S. I. No. M20-41

SERVICE INSTRUCTION**SUBJECT:** LANDING LIGHT SERVICE LIFE**MODELS****AFFECTED:** M20J, Serial Nos. 24-0002 thru 24-0757**TIME OF****COMPLIANCE:** At owners discretion.

FIGURE 1

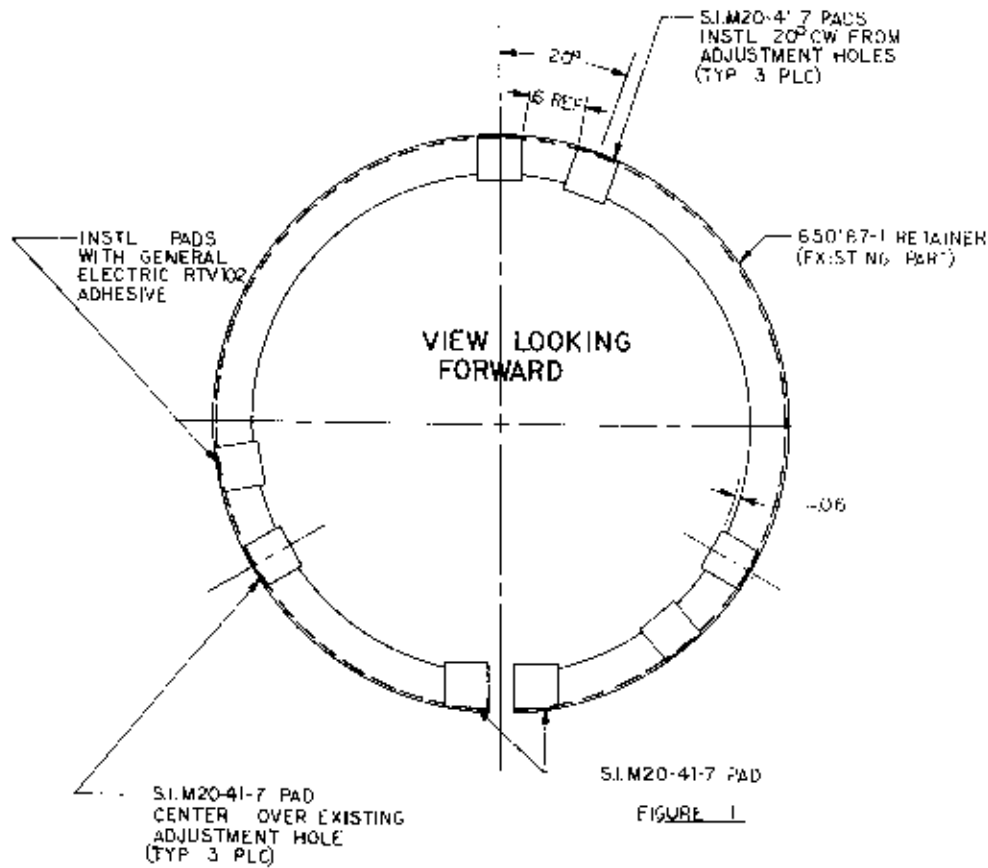
INTRODUCTION: On the aircraft noted above, the landing light is rigidly mounted to the engine cowling subjecting the lamp to excessive stress and vibration. Isolating the lamp and eliminating glass to metal contact by installing silicone sponge rubber pads greatly improves the lamp service life.

- INSTRUCTIONS:**
1. Remove landing light lens.
 2. Remove 650187-1 landing light retainer and landing light.
 3. Match drill and rivet S. I. M20-41-1 ring assembly to cowling per Figure 2.
 4. Install S. I. M20-41-7 pads (8 required) on 650187-1 landing light retainer. Per Figure 1.
 5. Re-install landing light, 650187-1 landing light retainer, and lens.
